Re: Casa Del Rey Parking Lot Grading and Drainage Engineer's Stamp Dated 3-12-02, (H11/D64)

RE: Casa del Rey Parking Lot (H11/D64)

Re: Casa del Rey Parking Lot Grading and Drainage Plan Engineer's Stamp Dated 3-12-02, (H11/D64)

Casa del Rey Parking Lot

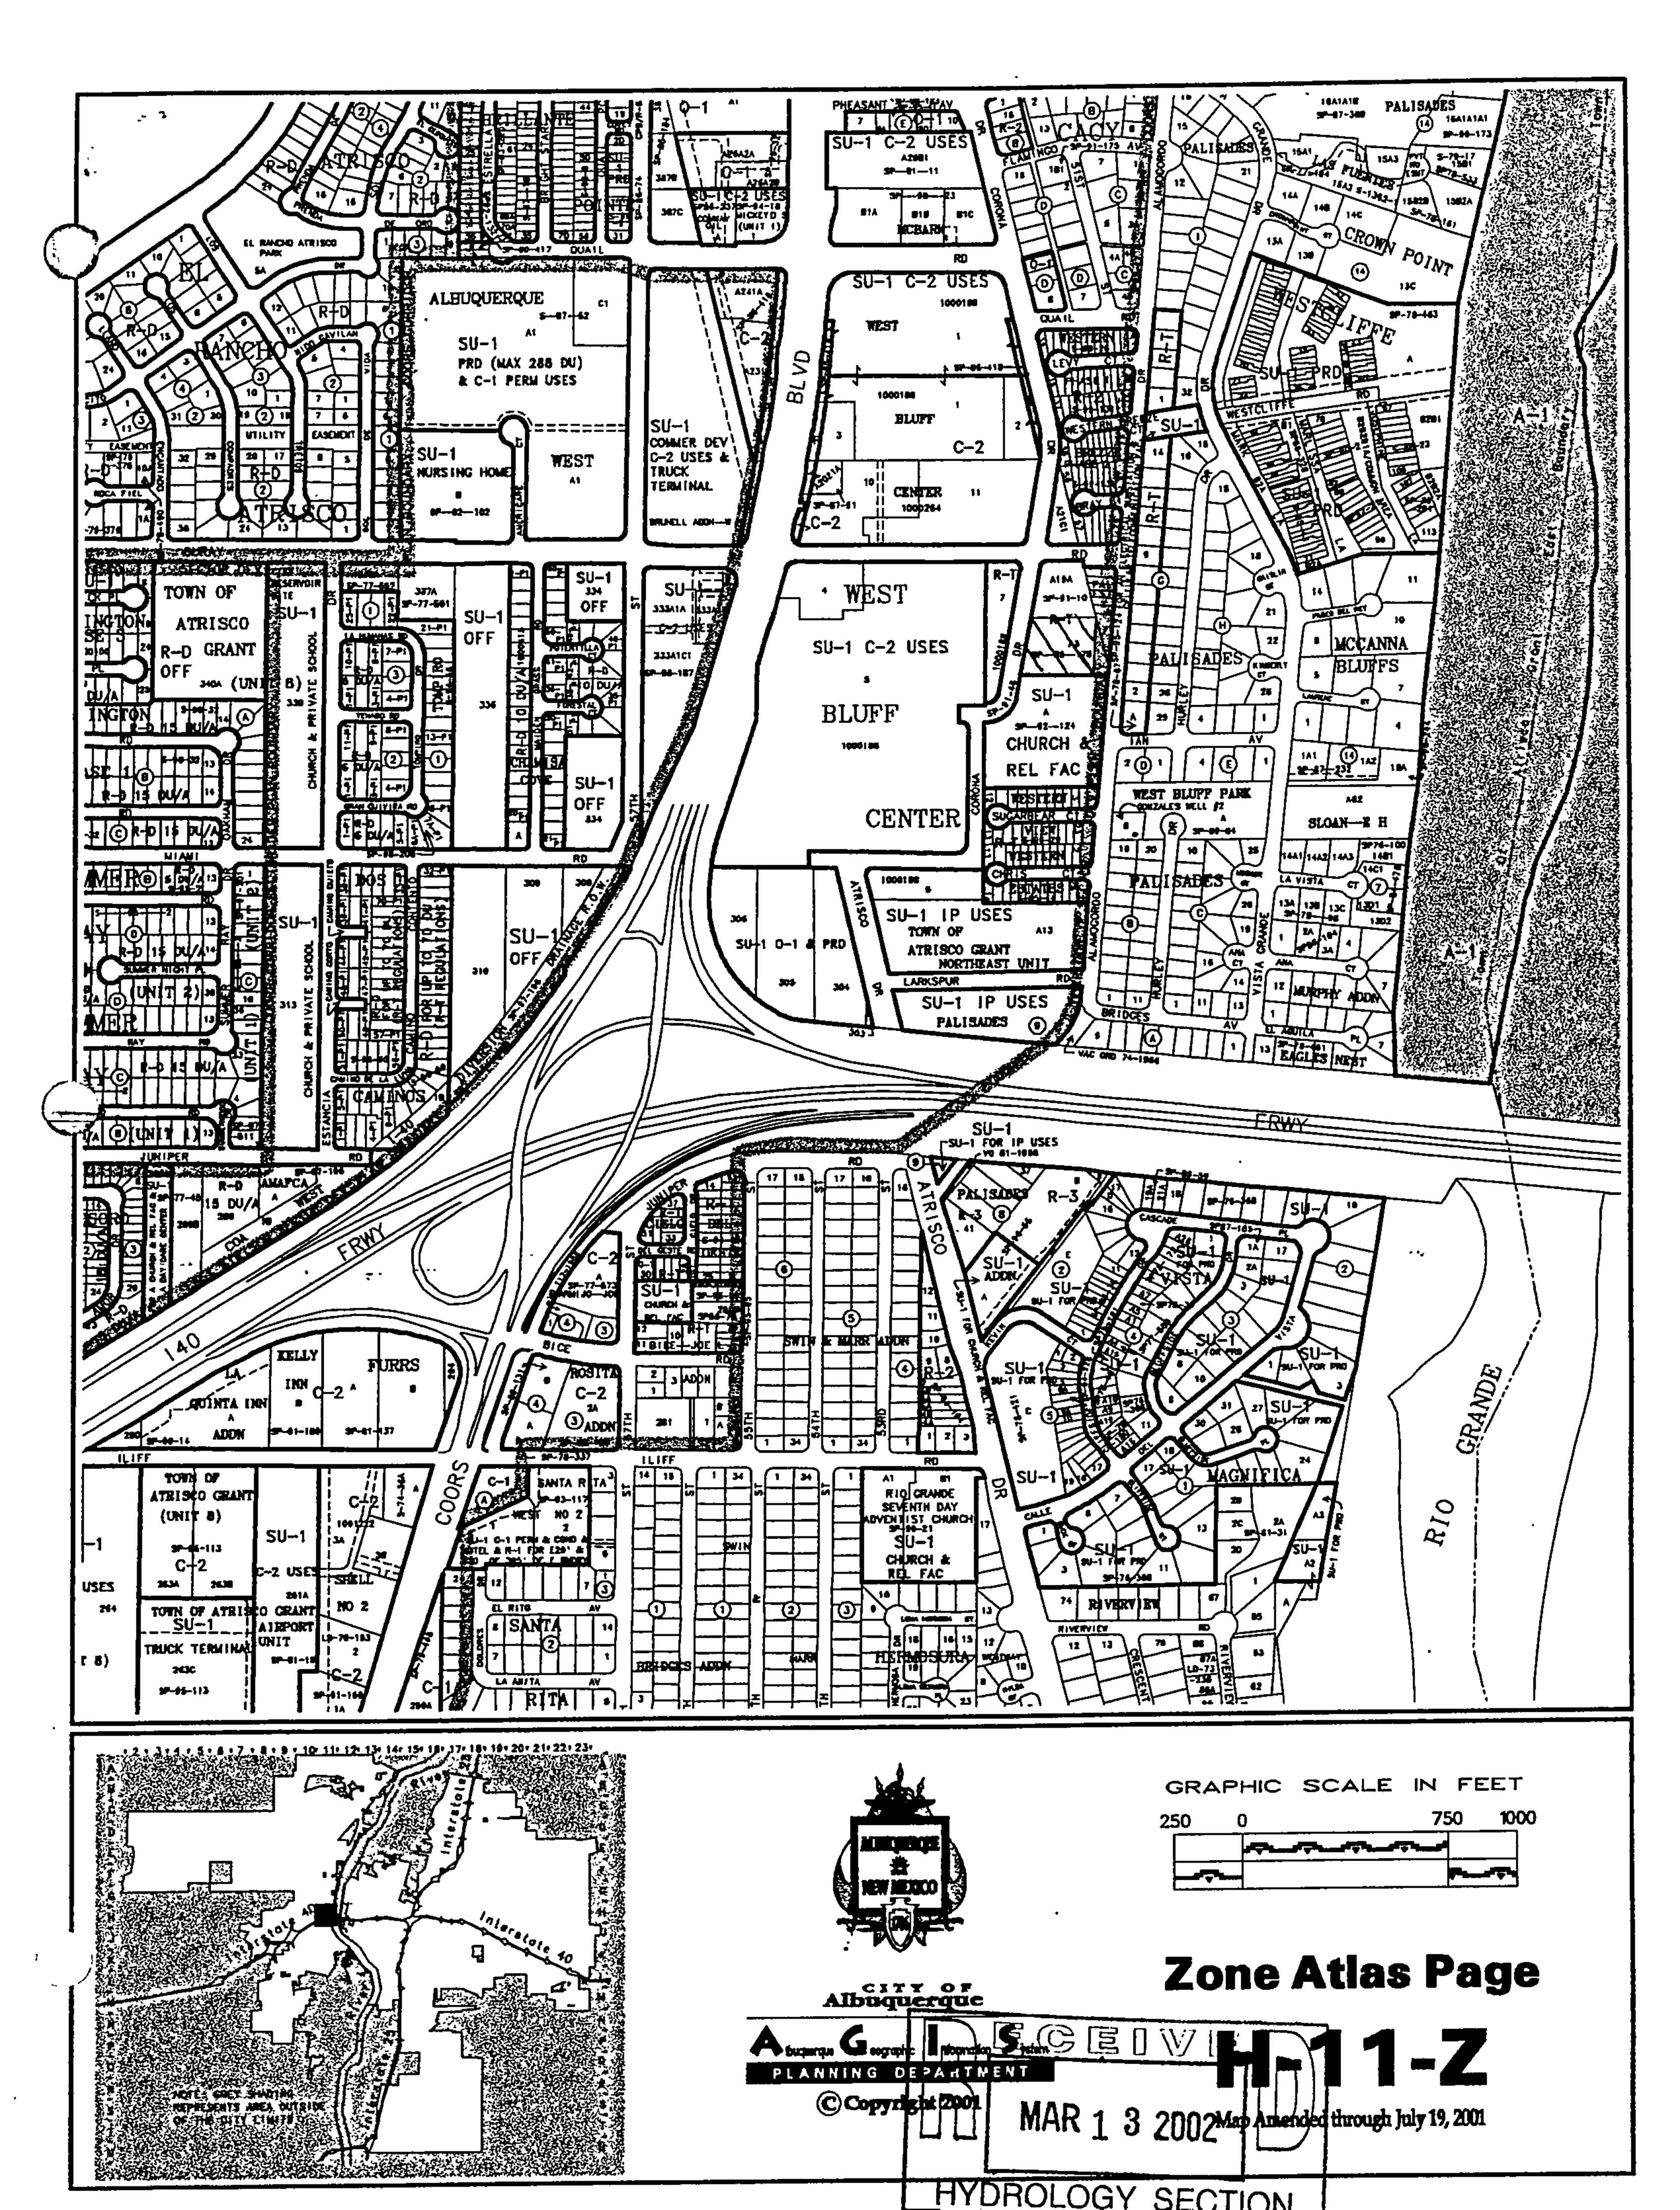
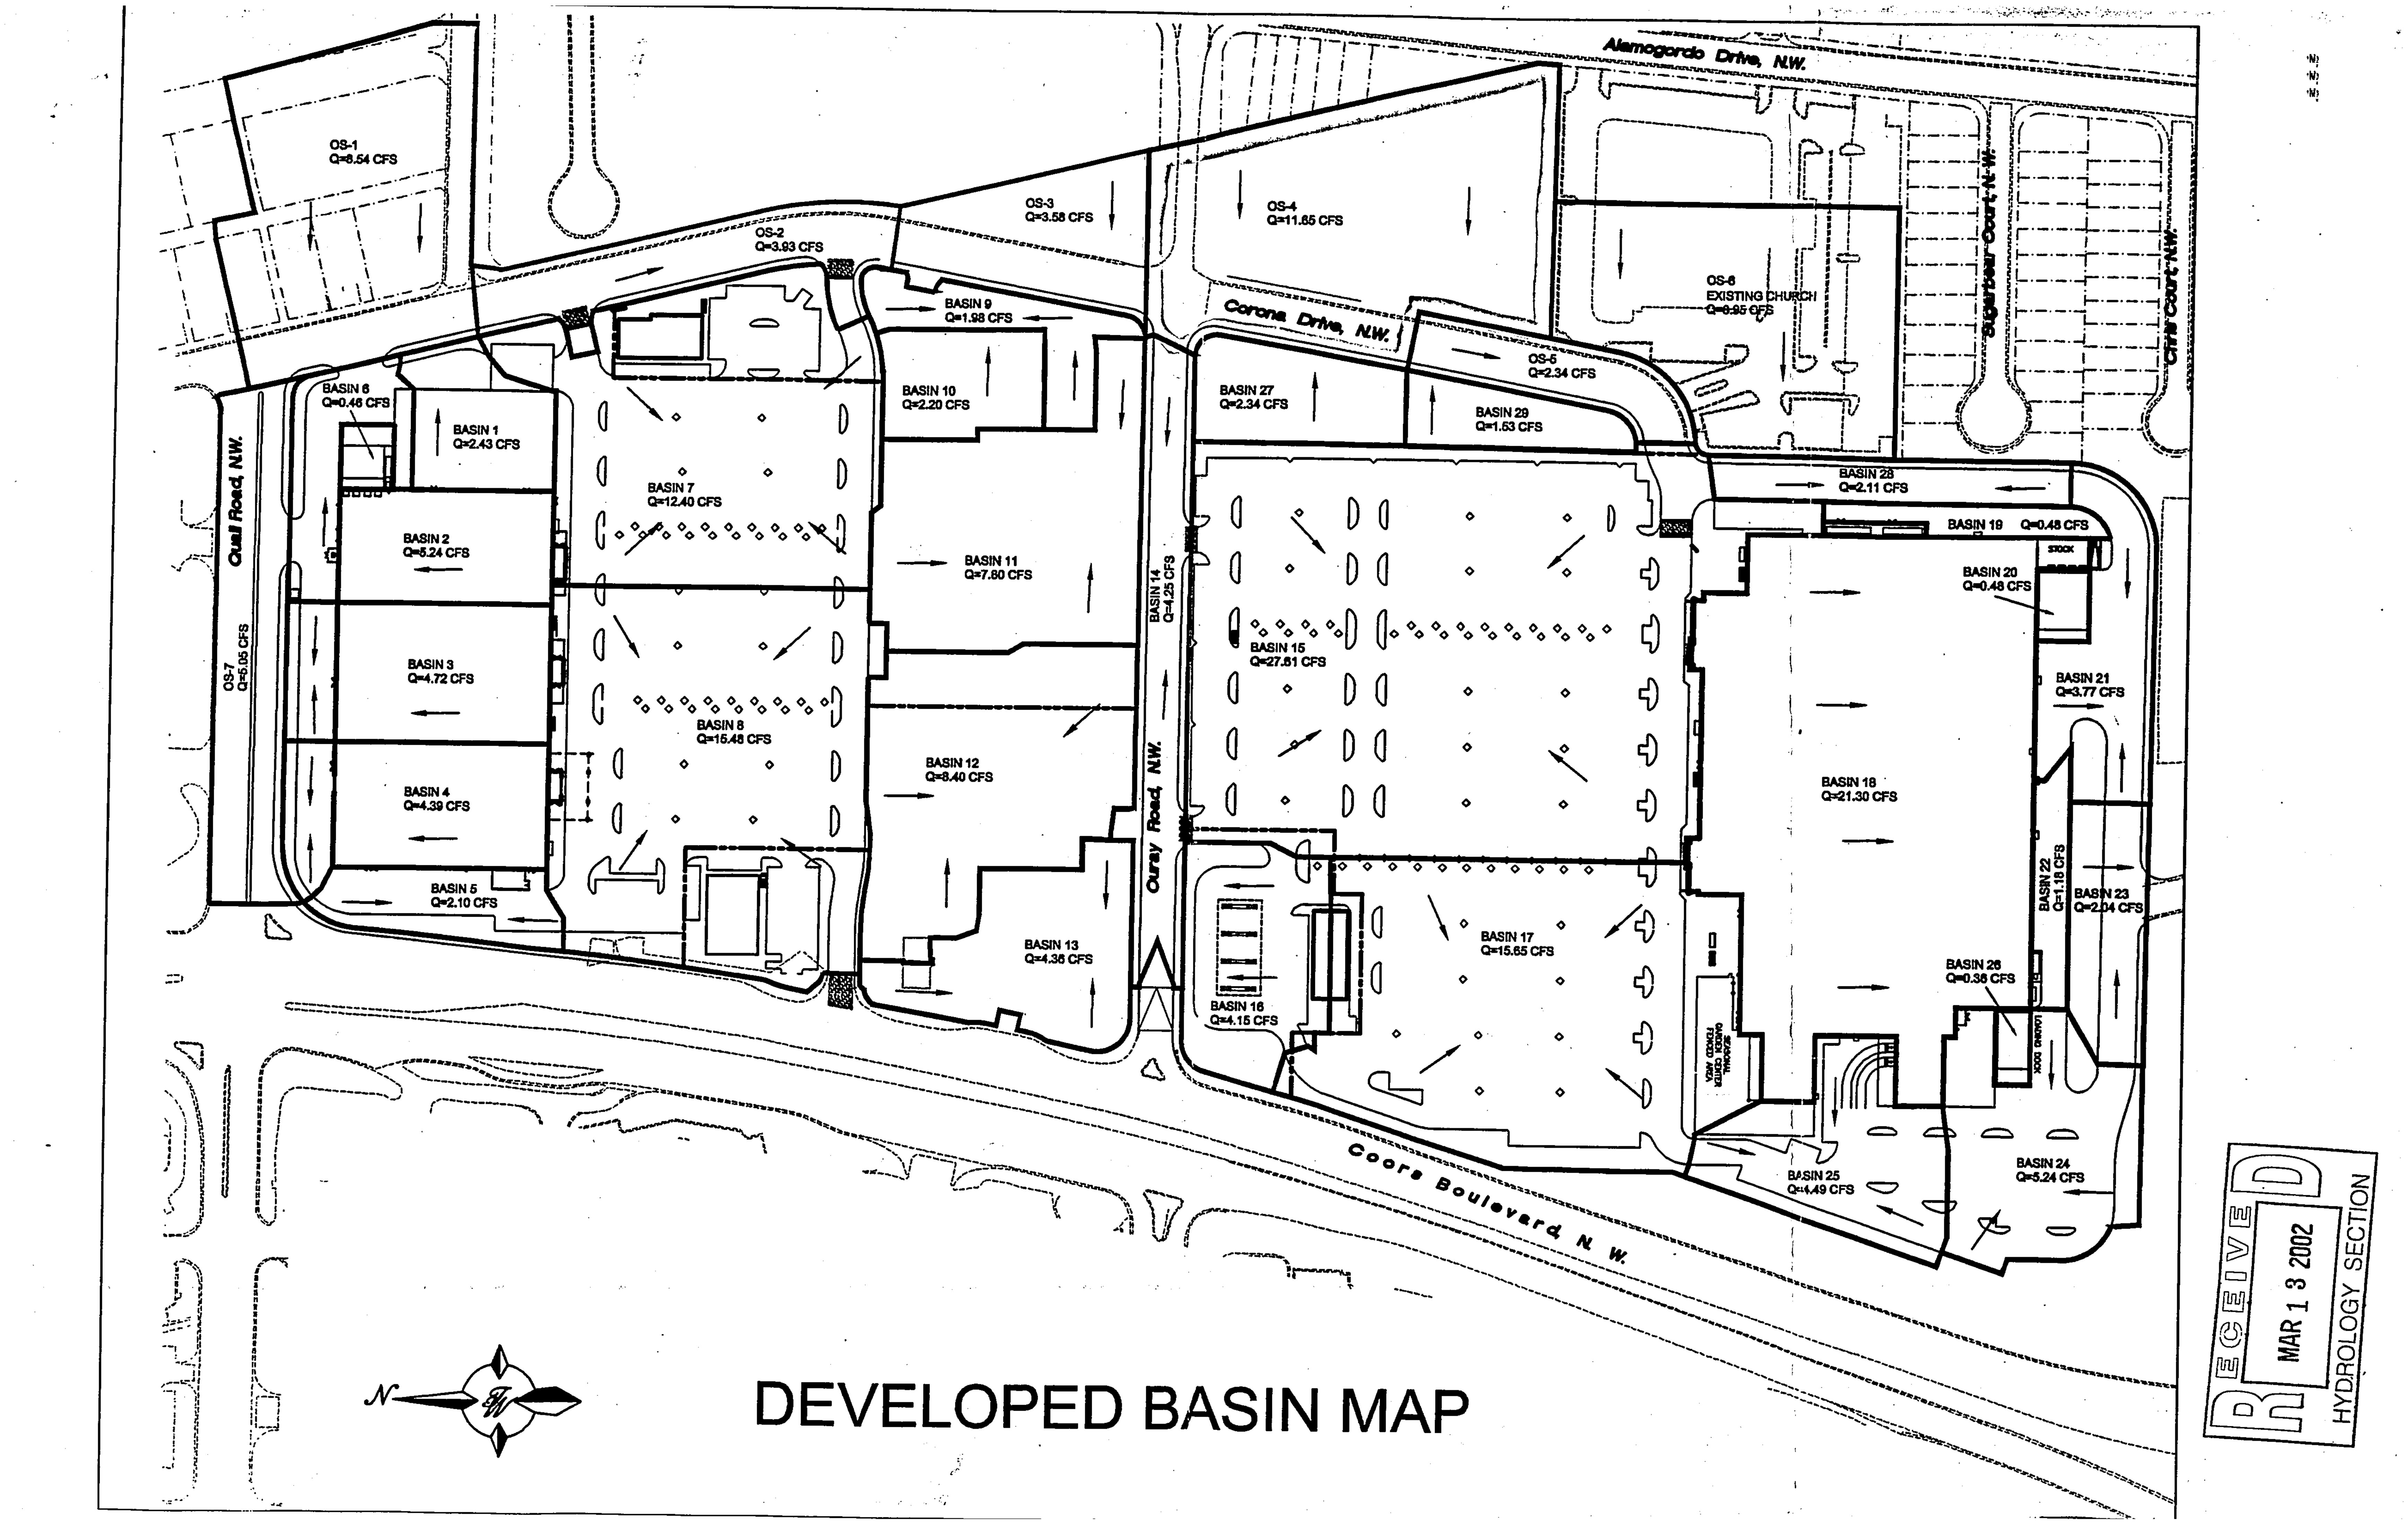
1. Please address if there are any off-site flows east of the proposed parking lot. It also appears that the portion to the east will be subdivided and drain to Alamogordo Street? If this is the case, spot elevations will be required between the lot line of the proposed parking area and the property to the east. Also, include spot elevations along Alamogordo Street as well.

Please address if there are any off-site flows east of the proposed parking lot. It also appears that the portion to the east will be subdivided and drain to Alamogordo Street? If this is the case, spot elevations will be required between the lot line of the proposed parking area and the property to the east. Also, include spot elevations along Alamogordo Street as well.

A Grading and Drainage Plan was prepared for the West Bluff Townhomes (H11/D49A) located east of this site. We have added the grades and layout for the Townhomes to show the continuity between the two projects.
